PETITION NO: SLUP-11

PROPOSED USE: Climate Controlled
Self-Service Storage Facility

PLANNING COMMENTS:

STAFF RECOMMENDATIONS

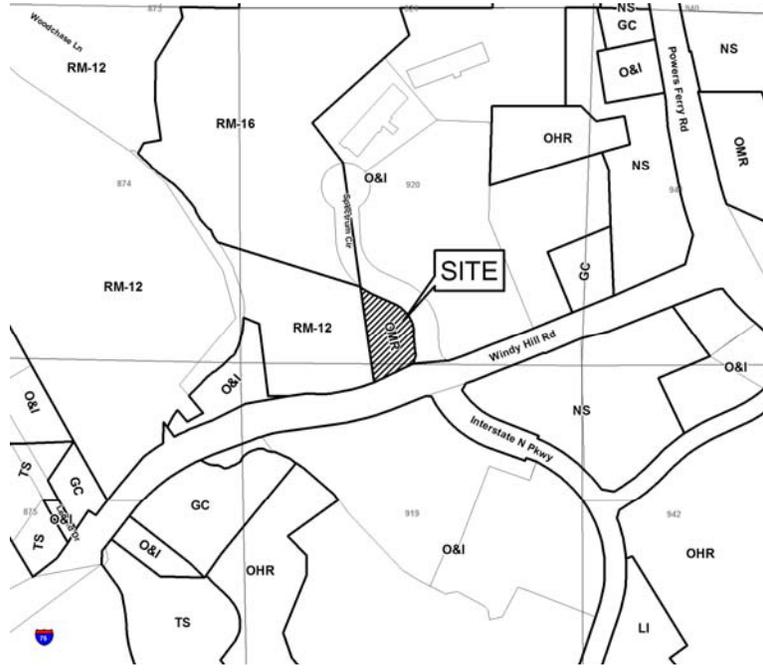
- Provide comprehensive hydrology/stormwater controls to include development of out parcels.
- Submit all proposed site improvements to Plan Review.
- Any **spring activity** uncovered must be addressed by a qualified geotechnical engineer (PE).
- Structural fill _____ must be placed under the direction of a qualified registered Georgia geotechnical engineer (PE).
- Existing facility.
- Project must comply with the Water Quality requirements of the CWA-NPDES-NPS Permit and County Water Quality Ordinance.
- Water Quality/Quantity contributions of the existing lake/pond on site must be continued as baseline conditions into proposed project.
- Calculate and provide % impervious of project site.
- Revisit design; reduce pavement area to reduce runoff and pollution.

- No Stormwater controls shown _____
- Copy of survey is not current - Additional comments may be forthcoming when current site conditions are exposed.
- No site improvements showing on exhibit.
